**Re: Rapiscan AIT System Radiation Survey Reporting**

**R-0646-1 Addendum  
(Documentation Errors)**

Product Name	Secure 1000SP (Single Pose)
Serial Number	S51006004
Radiation Emission Measurement	Radiation Survey Dated: 07/02/2010
RSO Initials

<b>Rapiscan</b> systems	<b>Secure 1000 Radiation Emission Measurement</b>	FORM R-0646-1 (Single Pose)
----------------------------	---------------------------------------------------	--------------------------------

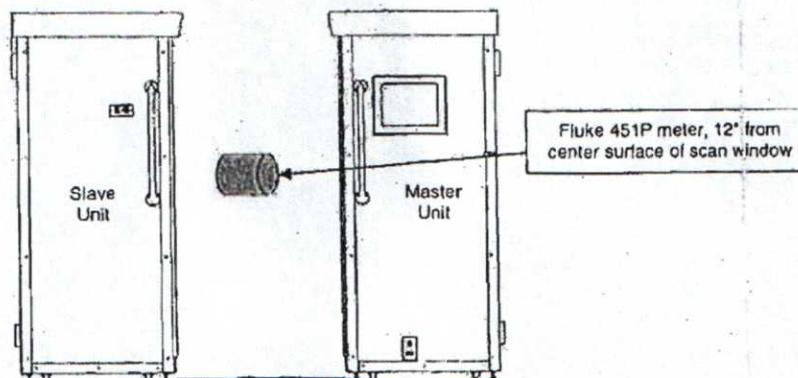
1. No value indicated for background radiation. Typical values range from 7uRem/hr to 13uRem/hr at sea level. Note: Absence of value has no adverse impact on calculations.
2. Technician indicated scan time as 7 seconds. Correct scan time is 3 seconds.
3. TABLE 1: Incorrect presentation of data in Column 3 for Measured Exposure. Indicated values are 30uR and 36uR. Corrected values are 3.0uR and 3.6uR. The values were corrected by technician when calculating Effective Dose.
4. TABLE 3: Incorrect presentation of data in Column 6 for Dose Equivalent. Indicated values are .18 uRem. The correct value should be 1.8 uRem.

The service technician should attend refresher training.

The corrected data indicates this system was operating within expected parameters. No re-survey is required for this system.
